ADDENDUM TO INVITATION FOR BID

RE: Addendum No. 3: IFB-NK-18-242 – FOREST HILLS OUTFALL MODIFICATION

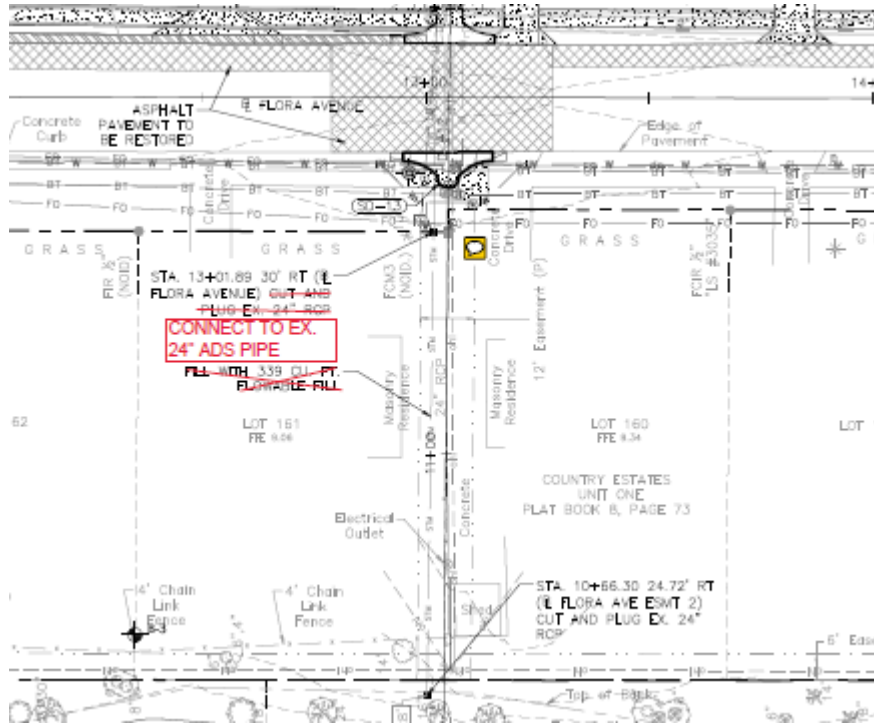
- b.
7. How is the biodegradable erosion control blanket specified in note #2 on plan sheet 23 paid for?
 - a. There is NO separate bid line item for this erosion control blanket.
 - b. Its cost is to be taken into account as part of the pipe installation cost
 8. Plan sheet 23 shows connecting to the existing 24” that runs south from SD-13. Plan sheet 24 calls for this pipe to be plugged and filled (note in center of the page). Which is correct?
 - a. Plan Sheet 23, shows connecting into the existing 24” pipe, which is correct.

- b.
- c. Initially, the intent was plugged and filled it as, stated in plan sheet 24.
- d. However, the existing 24" pipe has recently been replaced - replaced. For this reason, the work calls now is for a "tie in"
 - i. This construction plan page, #23, was provided to Purchase Dept via email, see insert below.
 - ii. Construction plan page #24 is been amended by the design engineer, as we speak. The revised sheet will be available soon

PAVEMENT RESTORATION DETAIL
N.T.S.

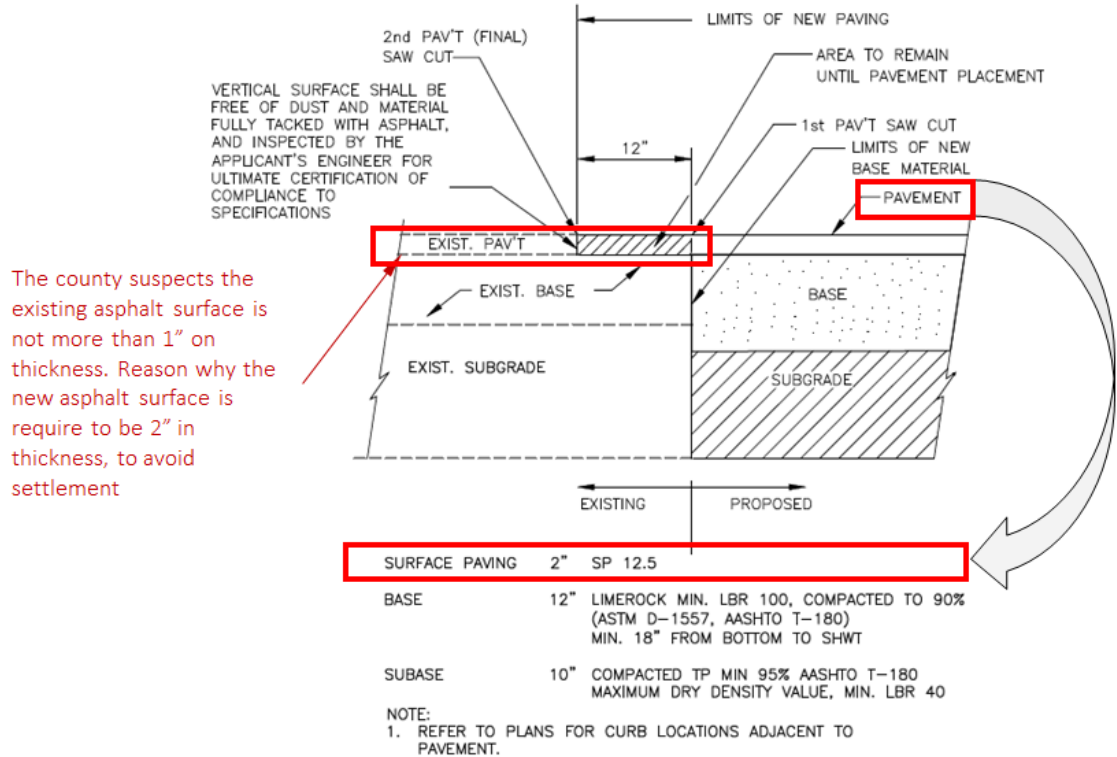
- e.
- 9. Are we to use the cut & patch detail or the pavement restoration detail on plan sheet 51 for the roadway restoration bid item?
 - a. Correct! The intent is to replace the existing asphalt with a 2" asphalt Surface

b. See revised Bid Line Item, below

NORTH WORK ZONE AREA					
ITEM No.	DESCRIPTION	UNIT	QUANTITY	UNIT PRICE	TOTAL PRICE
25	2" Asphaltic Concrete for ROADWAY RESTORATION	TON	100	\$	\$
26	CONCRETE DROP CURB	LF	294	\$	\$
